**For N1128-1 with serial numbers 0010 through 0059:**

Figure 1 – N1128-1 Alternator with Red B+ Link

Figure 2 – N1128-1 Alternator with B+ Wire Assembly

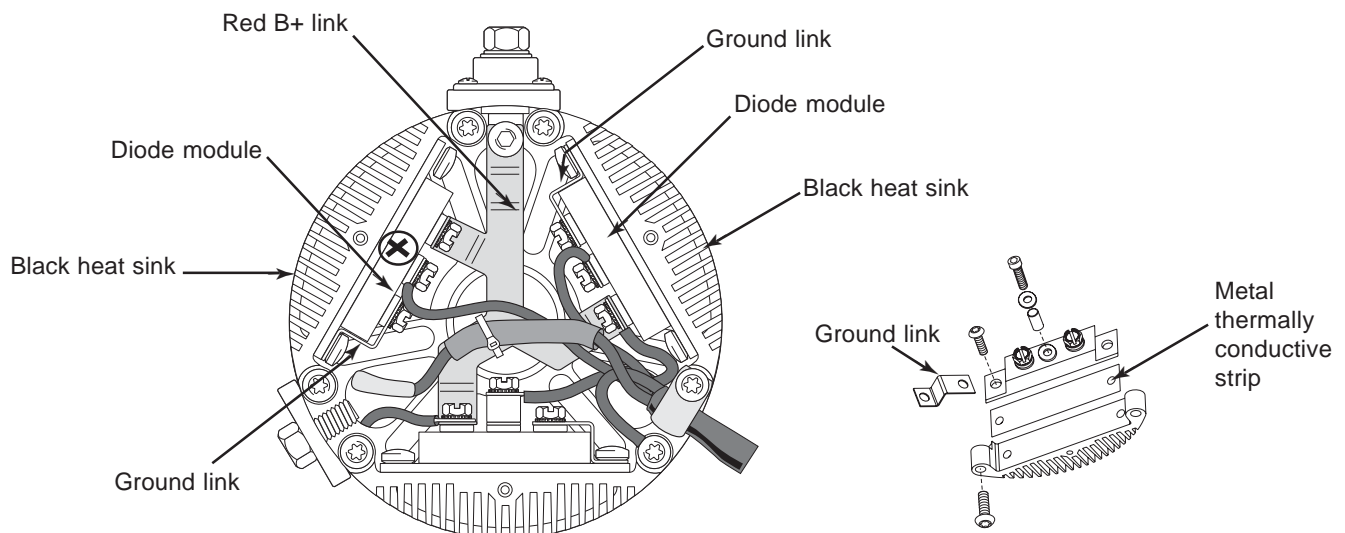
**If red B+ link needs to be replaced (see Figure 1):**

**Red B+ link is no longer available as a replacement part. Install new B+ wire assembly as described below:**

**If diode module needs to be replaced (see Figure 1):**

**Red B+ link should be replaced with new B+ wire assembly when replacing any diode module.**

If replacing one of the other two diode modules, the diode module marked with an "X" in Figure 1 must still be changed as described in step 4, since the new B+ wire assembly will be replacing the existing B+ link. Then follow the same steps to replace the other defective diode module, but don't rotate the new diode module.

1. Remove ADE cover plate and save hardware for reassembly.
2. Disconnect regulator harness wiring connections from diode modules. Leave field coil F- lead connection intact and disconnect field coil F+ lead from diode module.
3. Remove and discard red B+ link.
4. Remove and save the hardware attaching the diode module marked with an "X" in Figure 1 and the ground link connected to it. Discard the metal thermally conductive strip between the diode module and the black heat sink and replace with a new one. Rotate the diode module so the printed diode schematic side is on top. Reinstall the ground link in the position shown in Figure 2 on page 2. Torque diode module mounting screws to 12.5-13.6 Nm/ 9-10 lb. ft.
5. Go to "If B+ wire assembly needs to be replaced" on page 2, starting with step 4.

1. Follow steps 1-3 in "If red B+ link needs to be replaced" above.
2. If replacing diode module marked with an "X" in Figure 1, follow step 4 in "If red B+ link needs to be replaced" above to install the new diode module on the existing black heat sink.

3. Go to "If B+ wire assembly needs to be replaced" on page 2, starting with step 4.

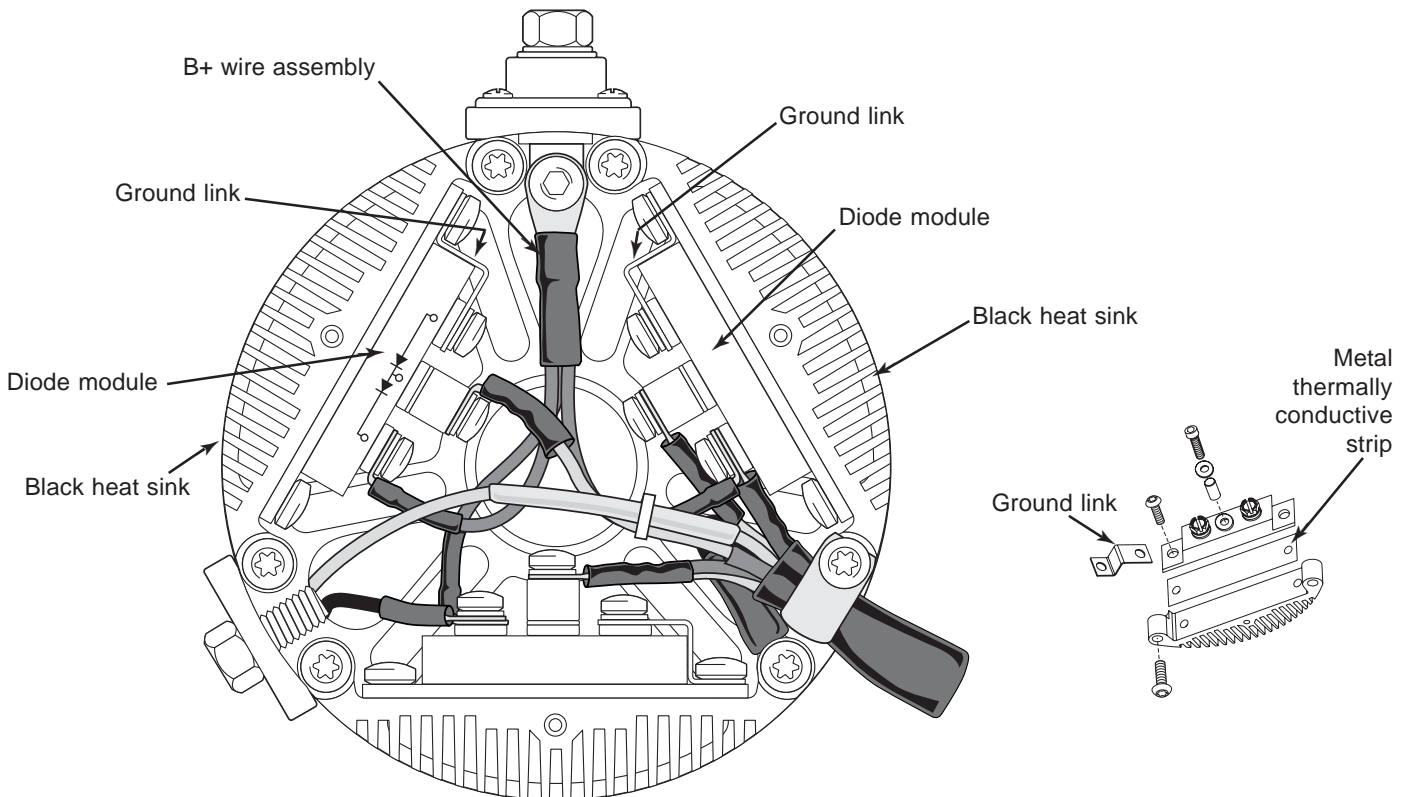
### If B+ wire assembly needs to be replaced (see Figure 2):

### If diode module needs to be replaced (see Figure 2):

1. Remove ADE cover plate and save hardware for reassembly.
2. Disconnect regulator harness wiring connections from diode modules. Leave field coil F- lead connection intact and disconnect field coil F+ lead from diode module.

3. Remove and discard defective B+ wire assembly.
4. Connect new B+ wire assembly:
  - a. To B+ stud and torque screw to 28-29 Nm/21-22 lb. ft.
  - b. To diode modules and torque all screws to 4 Nm/35 lb. in.

5. Connect regulator harness to module screws and torque screws to 4 Nm/35 lb. in. Connect green ground wire to heat sink and torque screw to 13.5 Nm/10 lb. ft.

6. Affix wire tie to field coil lead and one phase lead.
7. Using DMM (digital multimeter) set on diode test, connect red lead to B+ terminal on alternator and connect black lead to B- terminal on alternator. Meter should read OL (blocking). Reverse leads, meter should read less than 0.8 V (flow). If meter reads zero in either direction, recheck wiring connections and diode orientation.

1. Follow steps 1-2 in "If B+ wire assembly needs to be replaced" above.
2. Remove and save B+ wire assembly.
3. Remove and save the hardware attaching the defective diode module and the ground link connected to it. Discard the metal thermally conductive strip between the diode module and the black heat sink and replace with a new one. Reinstall the ground link in the position shown in Figure 2 below. Torque diode module mounting screws to 12.5-13.6 Nm/ 9-10 lb. ft.
4. Continue with step 4 in "If B+ wire assembly needs to be replaced" above.
